Addendum #1

PROJECT: Extend Runway 14/32 (1,100' x 75') – Phase II
AIP Project No. 3-23-0041-18-2018
Stephen A. Bean Municipal Airfield, Rangeley, Maine

DATE: April 13, 2018

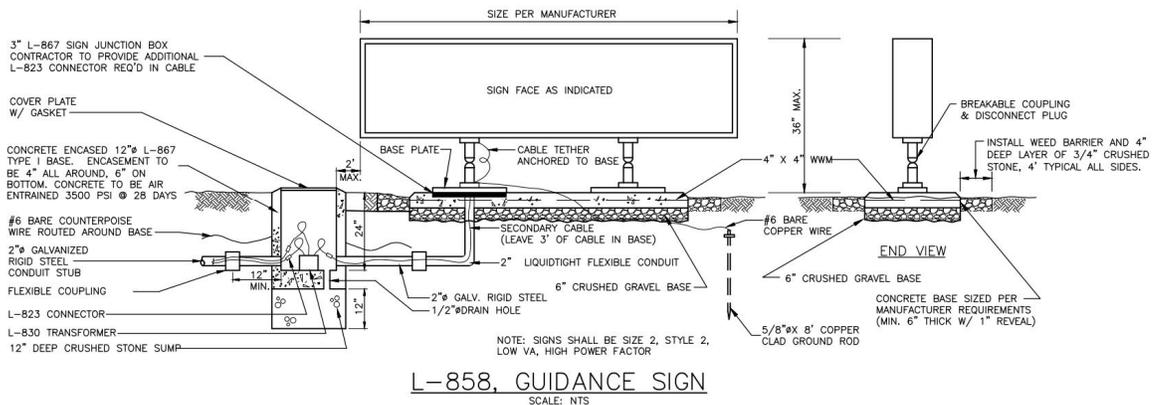
- 1. Item M-401 and M-304:** Add these items to the contract documents. M-401 Hot Mix Asphalt (LLR) & M-304 Aggregate Base will be used to for Loon Lake Road realignment and side road construction only. P-154 Subbase Course will continue to be used in the construction of Loon Lake Road and side roads.
- 2. Item P-152 – Excavation, Subgrade, and Embankment.** Rock Excavation shall be measured and paid for the activities that require ledge to be blasted, excavated and stockpiled only, including incidentals to these tasks such as survey, etc.

Rock Borrow shall be measured and paid for by processing these stockpiles as required to meet specification requirements, hauled, placed, compacted and accepted.
